Well Name: OLYMPIC	Well Location: T23N / R10W / SEC 3 / SWSW / 36.250671 / -107.889297	County or Parish/State: SAN JUAN / NM
Well Number: 4	Type of Well: OIL WELL	Allottee or Tribe Name:
Lease Number: NMNM23744	Unit or CA Name:	Unit or CA Number:
US Well Number: 300452681200S1	Operator: DUGAN PRODUCTION CORPORATION

Type of Submission: Notice of Intent	Type of Action: Plug and Abandonment
Date Sundry Submitted: 05/12/2025	Time Sundry Submitted: 01:42
Date proposed operation will begin: 06/12/2025

Notice of Intent - Plug and Abandonment

Operator: Dugan Production Corporation
Lease: NMNM23744
Well(s): Olympic 4, API # 30-045-26812
Location: SWSW Sec 3 T23N R10W (San Juan County, NM)
Sundry Notice ID#: 2852418

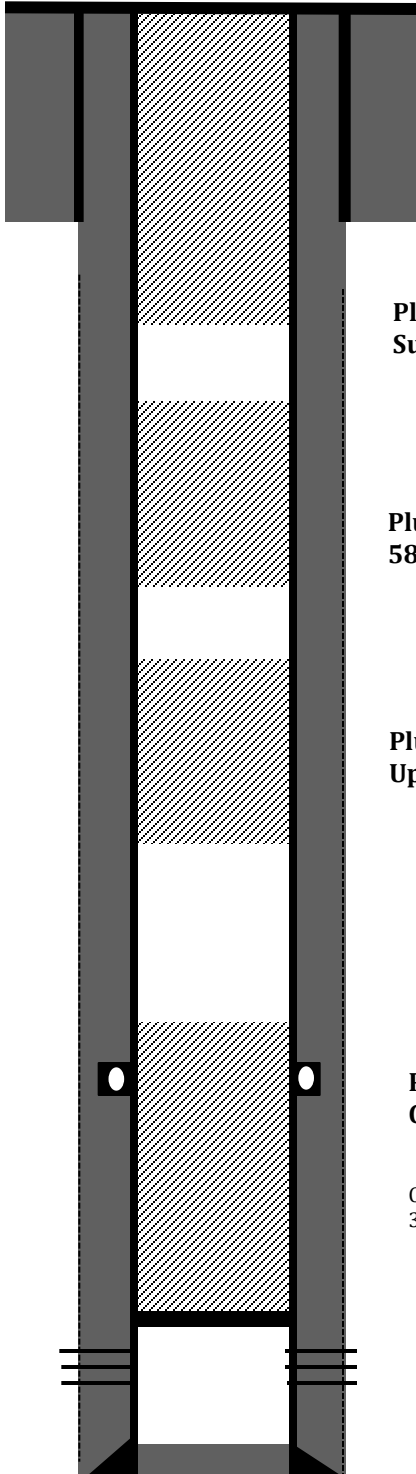
- a. Adjust Plug 1 (Mancos/DV Tool/Gallup) TOC to 3561' to cover BLM Geologist's Mancos formation top pick @ 3611'. Plug 2 should at a minimum cover 4421' up to 3561', estimated minimum 67 sx Class G.

- b. May adjust Plug 3 (Fruitland/Picture Cliffs) to cover BLM Geologist's Fruitland and Picture Cliffs formation top picks @ 745' and 1025', respectively. Plug 3 should at a minimum cover 1075' up to 695', estimated minimum 30 sx Class G.

- c. Adjust Plug 4 (Kirtland/Ojo Alamo/Surface) BOC to 399' to cover BLM Geologist's Kirtland formation top pick @ 349'. Plug 4 should cover 399' up to surface', estimated minimum 32 sx Class G.

Remarks: Please adjust plugs to account for BLM-picked formation tops.

Created By	Condition	Condition Date
mkuehling	NMOCD agrees with BLM formation tops - adjust plugs accordingly - Have been notified rig will be moving on May 20, 2025 - monitor string pressures daily report on subsequent - submit all logs prior to subsequent.	5/19/2025
